Product Change Notification

Change Notification #: 115843 - 00
Change Title: Intel® Server System R2312GZ4GC4,
PCN 115843-00, Product Design, Label,
Regulatory and Safety Label Updates;
Motherboard Update
Date of Publication: October 11, 2017

Figure-1: Pre-Change

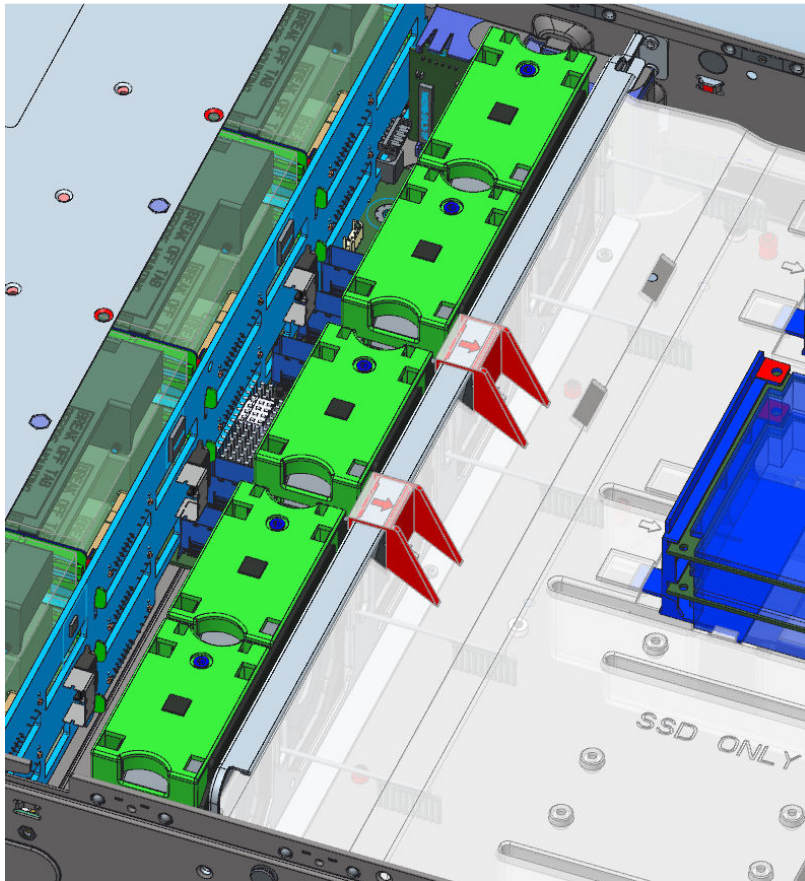
3. Update Motherboard to PBA G11481-356 with the below changes:
 - a. Update the PBA label using a small label with RCM logo to cover C-Tick logo. Please see Figure-1 and Figure-2 below for details.

BEFORE

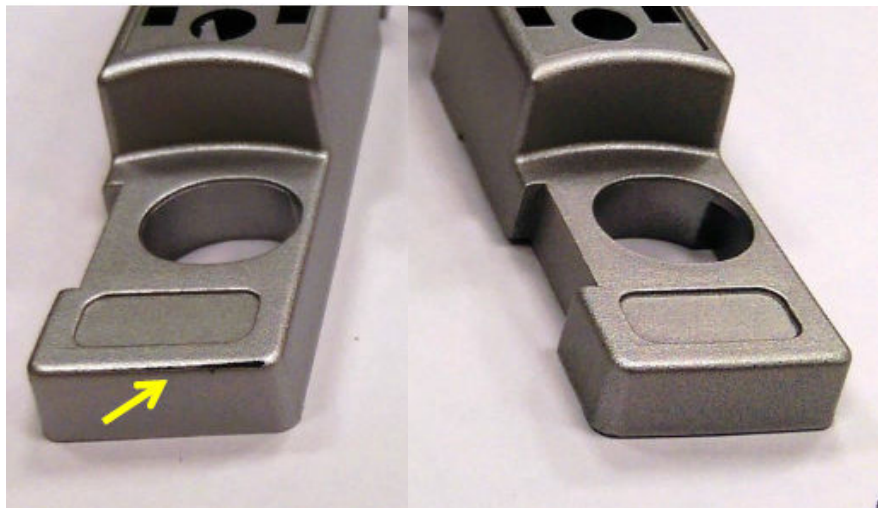
5. Improve painting quality on rack ear with UV paint to improve the coating durability. Same painting color, no visible change in the rack ear.
